**STAFF RECOMMENDATION**

**945 S Douglas Avenue, Unit #2**

**February 17, 2021**

**Application:** New Construction – Infill/Part II SP

Figure 5. First floor plan. Note recessed porch at the bottom left.

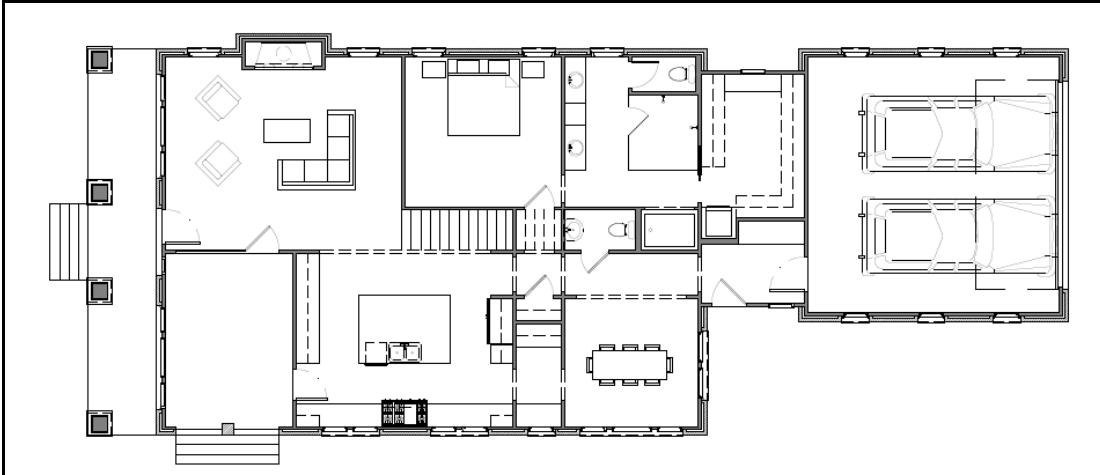
**Orientation:** The infill faces the street and sidewalk. There is a walkway from the front door. The house has a traditional front porch that is six feet (6') deep. The house also has a recessed porch, located to the right of the front door, behind the front wall of windows. (Figure 5) This porch will have three walls and will be accessible from the living room, from the kitchen, and from the side yard via voids seen in the wall on the south elevation (Figure 4). This is a slightly unusual feature but allows for semi-protected outdoor space at the front of the house and meets the design guidelines. This porch could be enclosed into an interior room in the future and would still meet the guidelines.

Figure 7. Massing study from Part I SP application

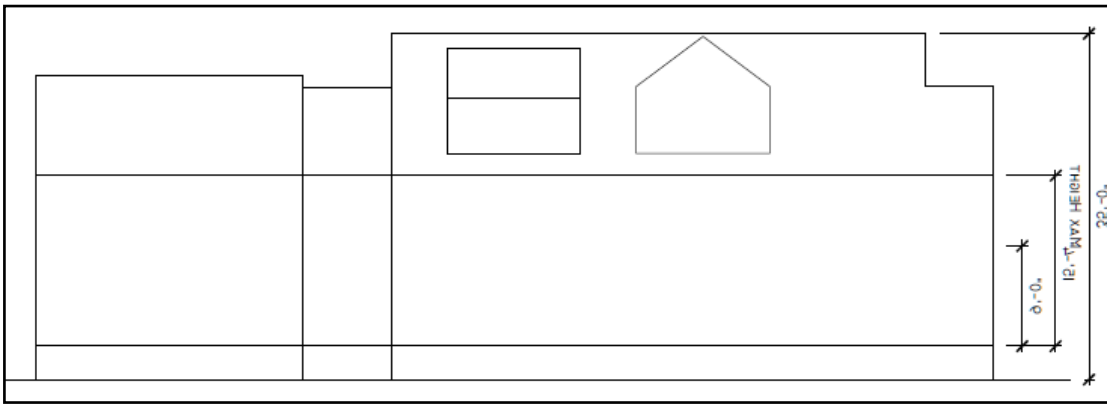
**Outbuildings:** As per the approved SP, all nineteen (19) of the houses in this project will include an attached garage accessed off of the rear private drive. The massing studies from the part I SP application show the attached garages for the thirty-five foot (35') tall one-and-a-half story units #1-#7 as subservient in height with a ridge height of approximately twenty-seven feet (27') from grade and an eave of fifteen feet, four inches (15'4") from foundation. (Figure 7)

The proposed attached garage has a ridge height of about twenty-three feet, six inches (23'6") from grade and an eave of about twelve feet (12'). Staff finds that the proposed massing, which keeps the garage and connector lower and subservient, while matching the eave height of the house, is consistent with the SP approval.

Staff finds that the proposed attached garage is consistent with the massing and site plan of the approved SP.
